HISTORIC PRESERVATION COMMISSION
AUGUST 25, 2022
ASSEMBLY HALL

PINEHURST, NORTH CAROLINA
4:00 PM

To: Historic Preservation Commission
From: Alfred Cassidy, Senior Planner
Alex Cameron, Planning Supervisor
CC: Shannon Konstantinou, Administrative Specialist
Maria Carpenter, Planner
Date: August 17, 2022
Subject: **Major COA Request for 80 Carolina Vista (*Continued from July 28, 2022 Meeting)***

EXHIBIT A-2.5

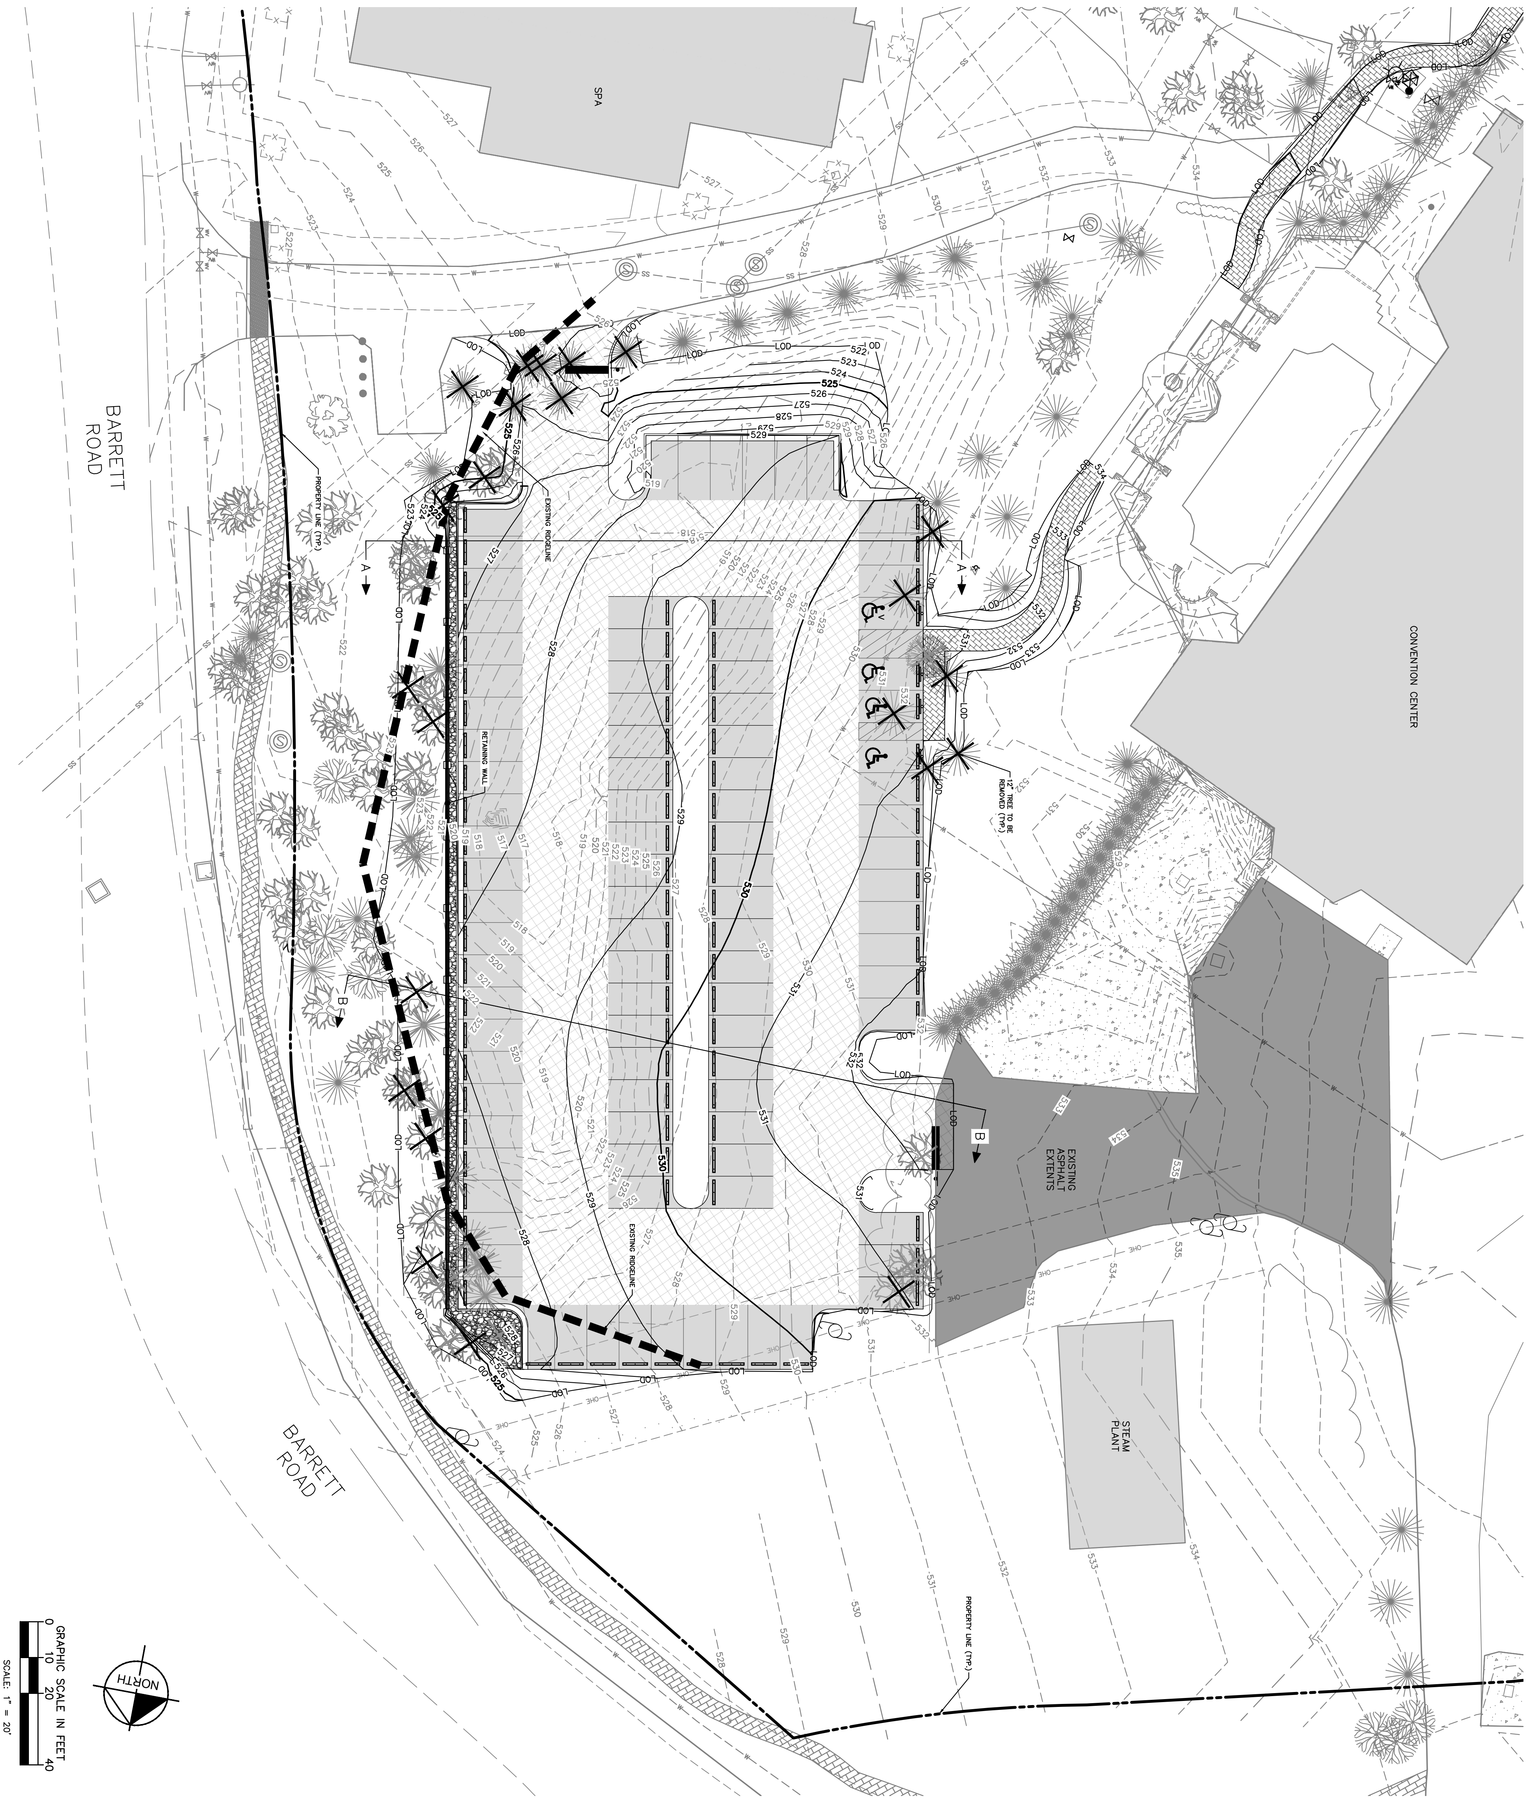
The applicable Standard indicates that the removal of trees of this size must not unreasonably compromise the existing tree canopy. The applicant has indicated with a revised plan showing approximately 23 trees are to be removed that are greater than 12"DBH (see Exhibits A-2.5 and A-2.6). Additionally,

approximately 40 trees are required to be installed to meet the parking lot landscaping requirements of the Pinehurst Development Ordinance (PDO). These trees will be a mix of longleaf pines, large hardwoods, evergreens and flowering understory trees. The applicant has provided an additional exhibit to help better illustrate the required plantings (see Exhibit A-2.7). The trees, if removed, would impact the existing canopy and the newly installed trees would help provide an additional canopy at time of planting and in the future. The Commission will need to determine if the proposed removal along with the new plantings would unreasonably compromise the existing canopy of the site.

Aerial Map EXHIBIT S-2

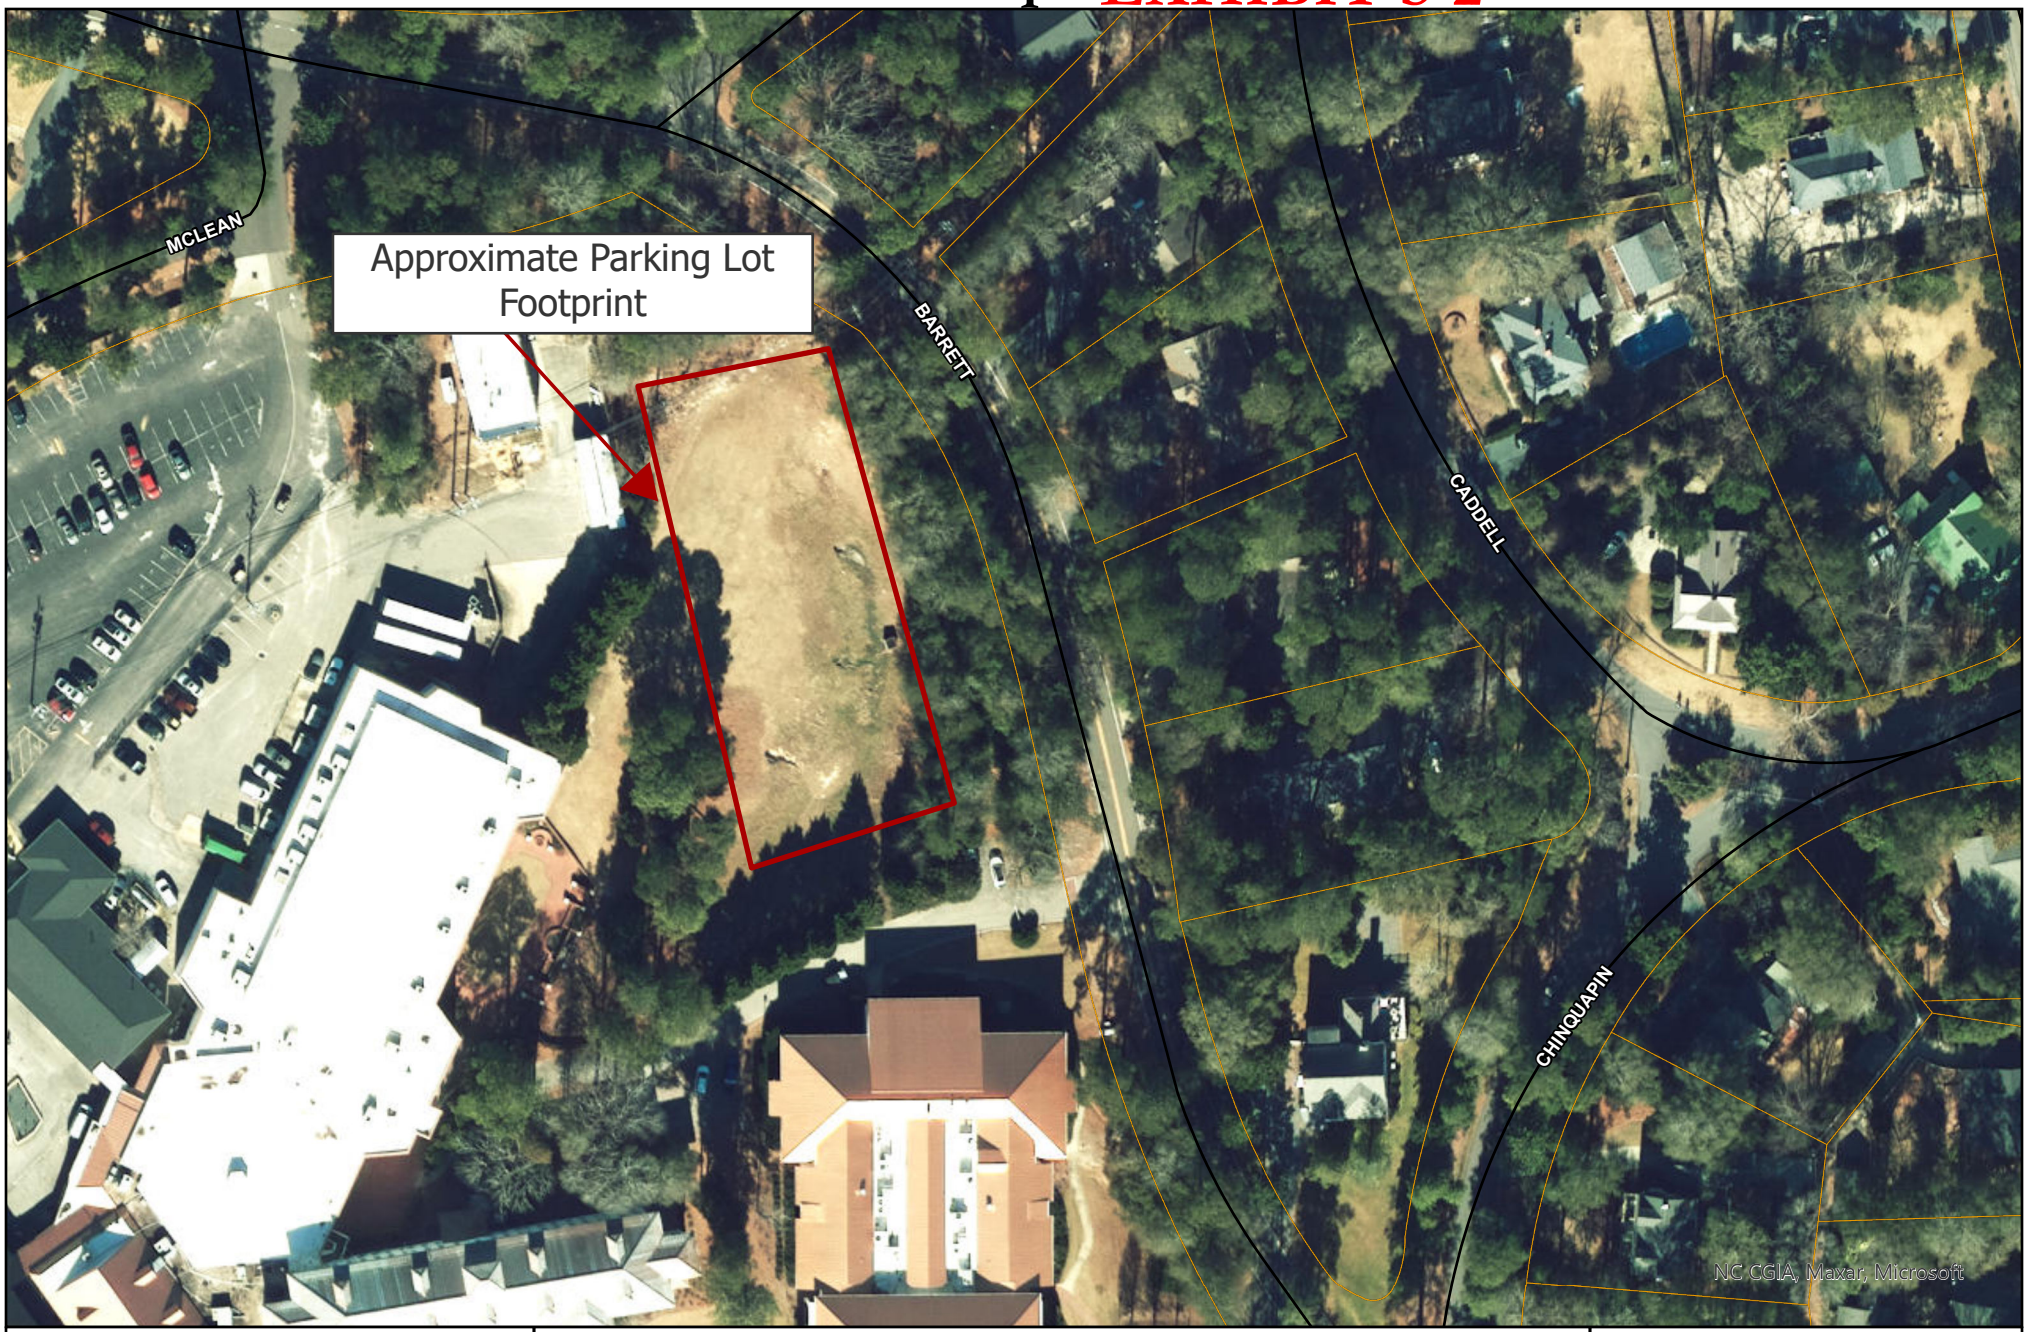
Mr. Herring asked to view Exhibits X-1.5 to X-1.7. The Commission, Mr. Burkley, Mr. Cochran, and Mr. Harrison discussed whether the relocation of the parking lot 10-15' to the west (in the general direction of the Convention Center) of the proposed location was possible, the potential to reduce the number of trees proposed for removal by relocating the proposed parking lot to the west, and how many parking spaces would be lost should the proposed parking lot be relocated to the west. Mr. Burkley, Mr. Cochran, and Mr. Harrison stated a definitive answer as to whether the relocation of the proposed parking lot is possible could not be given without further consideration and approximately 6 parking spots would be lost should the proposed parking lot be relocated. The Commission, also, reviewed Exhibit S-2 depicting the approximate location of the proposed parking lot.
